IEEE 802.3cg

Interworking between PLCA enabled nodes with non-PLCA enabled nodes

September 10th, 2018

Figure 148-5—PLCA Control state diagram (2 of 2)

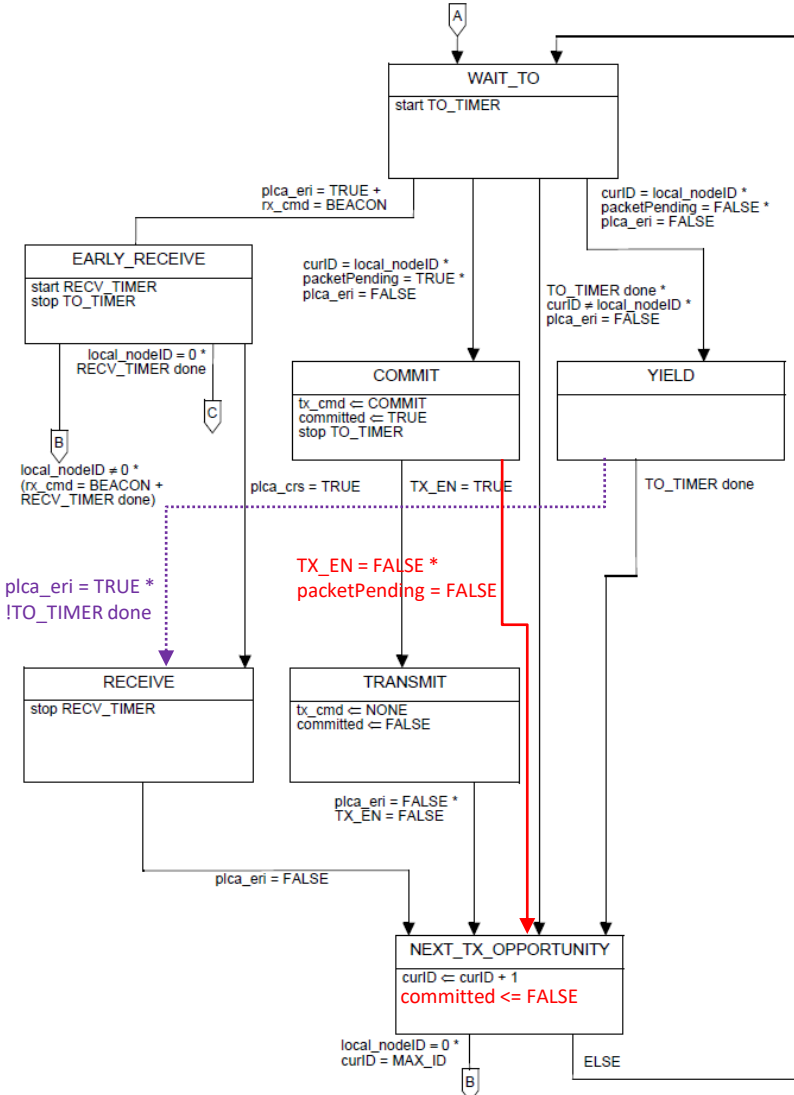
Add transition from YIELD to RECEIVE state with condition “plca_eri = TRUE * !TO_TIMER done”

Add transition from COMMIT to NEXT_TX_OPPORTUNITY state with condition “TX_EN = FALSE * packetPending = FALSE”

Add “committed <= FALSE” in NEXT_TX_OPPORTUNITY state box

Figure 148-7—PLCA DATA state diagram (2 of 2)

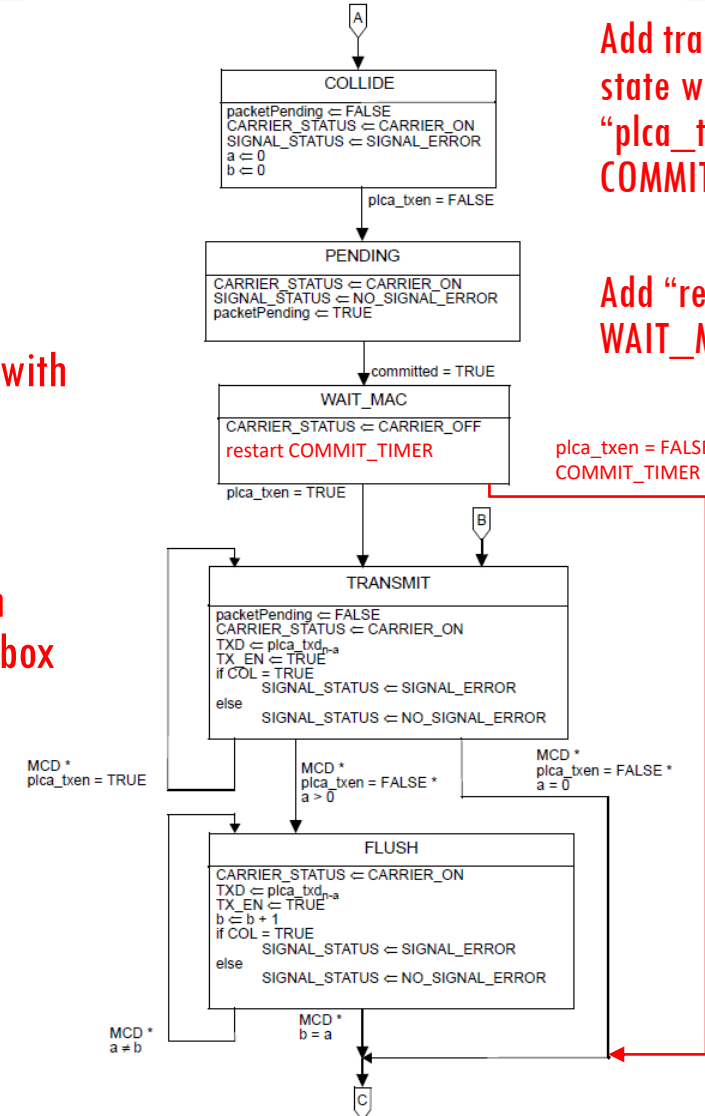
Add transition from WAIT_MAC to COLLIDE state with condition “plca_txen = FALSE * COMMIT_TIMER done”

Add “restart COMMIT_TIMER” in WAIT_MAC state box

plca_txen = FALSE * COMMIT_TIMER done

- 148.4.6.4 Timers
 - COMMIT_TIMER
 - Defines the maximum time the PLCA Data state machine is allowed to stay in WAIT_MAC state.
Duration: 192 bit times
- 45.2.3
 - Add register 3.2294 “10BASE-T1S PCS Diagnostic 2”
 - Add register description
